City of Ann Arbor – Sanitary Sewer Wet Weather Evaluation Project Volume 4: Hydraulic Report November 2014

Collection System Action Plans

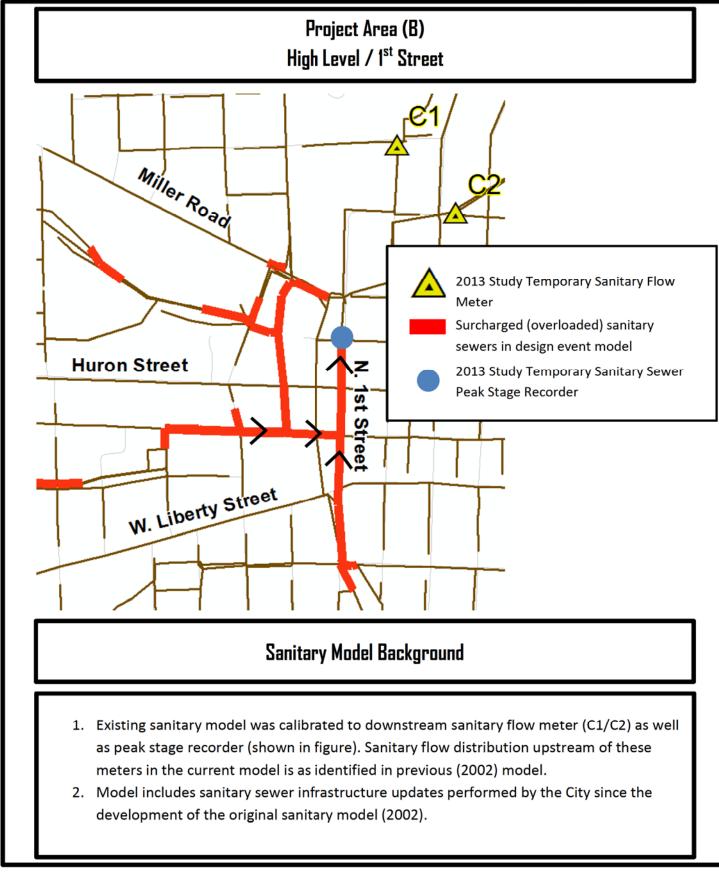
- 1- Sanitary sewer model shows sanitary flows that exceed the sanitary sewer pipe capacities as identified in the adjacent figure, resulting in modeled surcharging as high as \sim 15 ft. above the sanitary sewer bottom.
- 2- The City had previously recognized this as a problem area and constructed a relief sanitary sewer downstream of meter B1. Further work was planned but extent of improvements needed was yet to be identified.
- 3- The City complaint data (sanitary sewer backup report) does not show reported sanitary backups in this area.

Therefore, we do not have high confidence in the surcharging identified by the sanitary sewer model and recommend action items listed below before making significant capital investments.

CAC COMMENTS:

- 1. Identify locations for additional temporary sanitary metering and other data collection (e.g. video inspection) in order to better understand actual sanitary system performance.
- 2. Perform temporary sanitary flow metering and data collection.
- 3. Revise sanitary model based on findings.
- 4. Re-run sanitary model for design event to identify deficiencies.

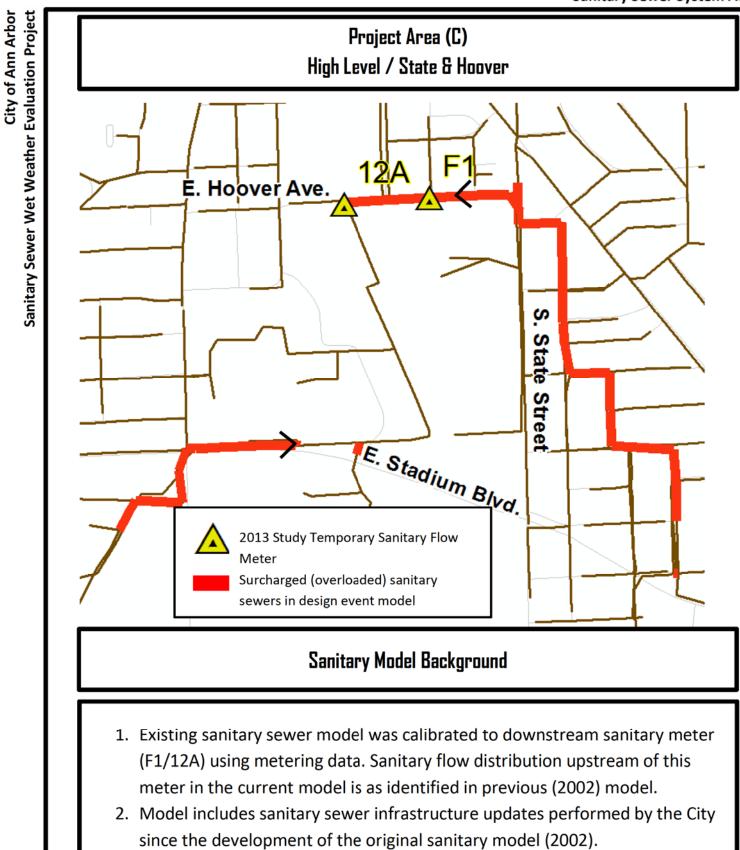
- 1- Sanitary model calibration efforts show that very high hydraulic losses, i.e. blockages, needed to be applied in order to make the sanitary model match peak stage recorder (PSR) data (location of PSR is shown on map). These losses, i.e. blockages, are much higher than suggested by engineering standards.
- 2- Design event sanitary sewer model calibrated to the PSR shows flows that exceed the sanitary pipe capacities, resulting in modeled surcharging as high as ~8 ft. above sanitary sewer bottom.
- 3- The City had previously recognized this as a problem area. Further work was planned but extent of improvements needed was yet to be identified.

Therefore, it is believed that further investigations are needed to resolve the unusual hydraulic losses before making significant capital investments.

CAC COMMENTS:

- 1. The 18" sanitary sewer, set west of First St., runs north from Washington St directly under what is known as the Atrium Office building (315 W Huron).
- 2. Examine the results of the stormwater model calibration study to determine if stormwater flooding might be contributing to issues in this area.

- 1. Install branch flow meters to verify the flows in this area.
- 2. Televise and physically inspect sanitary pipes and manholes.
- 3. Perform field sanitary flow testing if feasible by directing water from a hydrant into the sanitary sewer.
- 4. Organize a wet weather mobilization team to measure sanitary depths during storm events.
- Perform continuous sanitary depth and flow meter monitoring at key locations, if needed.

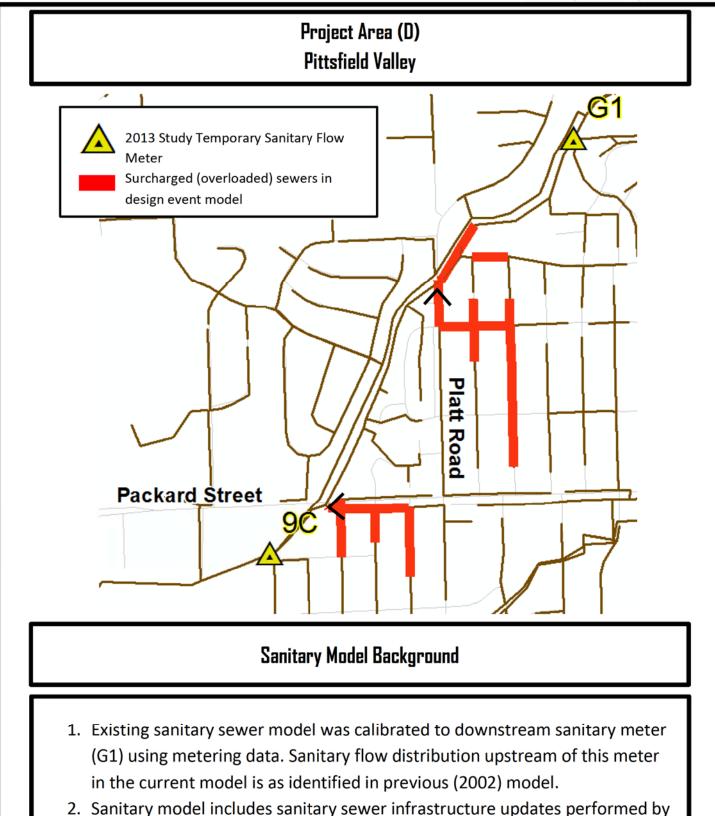
- 1- Sanitary sewer model calibration efforts show that very high hydraulic losses needed to be applied in order to make the model match sanitary flow meter data. These losses are much higher than suggested by engineering standards.
- 2- Design event sanitary sewer model calibrated to the downstream sanitary flow meter shows flows that exceed the sanitary pipe capacities, resulting in modeled surcharging as high as ~8 ft. above sewer bottom.
- 3- The City had previously recognized this as a problem area. Further work was planned but extent of improvements needed was yet to be identified.
- 4- This is a known Sanitary Sewer Overflow (SSO) area upstream of meter F1.

CAC COMMENTS:

1. Consider monitoring the sanitary depth downstream to understand where the sanitary back-ups begin.

- 1. Televise and physical inspect sanitary pipes and manholes.
- 2. Perform field sanitary flow testing if feasible by directing water from a hydrant into the sanitary sewer.
- Organize a wet weather mobilization team to measure sanitary depths during storm events.
- Perform continuous sanitary depth and flow meter monitoring at key locations, if needed.

Project Area (E) Glen Leven

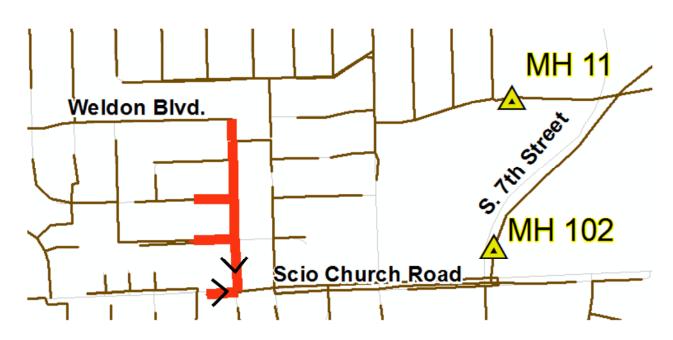
- 1- Sanitary model shows sanitary flows that exceed the sanitary pipe capacities for approximately 1,800 ft., resulting in modeled surcharging as high as ~3 ft. above sanitary sewer bottom.
- 2- This is one of the high-priority footing drain disconnection areas (Glen Leven).
- 3- Sanitary metering data analysis indicated that footing drain disconnection was less effective in this area than in the other high-priority areas.
- 4- High flows from inflow & infiltration into the sanitary system still exist in this district, either from remaining footing drains or other inflow & infiltration sources.

CAC COMMENTS:

- 1. What is our level of confidence in the model in this area, and the prediction of 3-feet of surcharge? OHM indicated high confidence.
- 2. There were some concerns expressed by OHM about the flow split between the two meters on this area. Does that affect the confidence? No. The meter data was used to distribute the sanitary flow in the model.
- 3. Should the City consider some "free board" above the three feet of surcharge to provide some cushion before basements are impacted? CAC recommends two feet.

- 1. Determine sanitary surcharge level that impacts basements.
- Develop a scope and cost for sanitary sewer evaluation survey (SSES), inclusive of televising, sanitary manhole inspection, smoke testing, and temporary sanitary flow monitoring.
- 3. Prepare a preliminary cost estimate for a sanitary relief sewer.
- 4. Perform cost effectiveness evaluation between construction of relief vs further I/I removal.
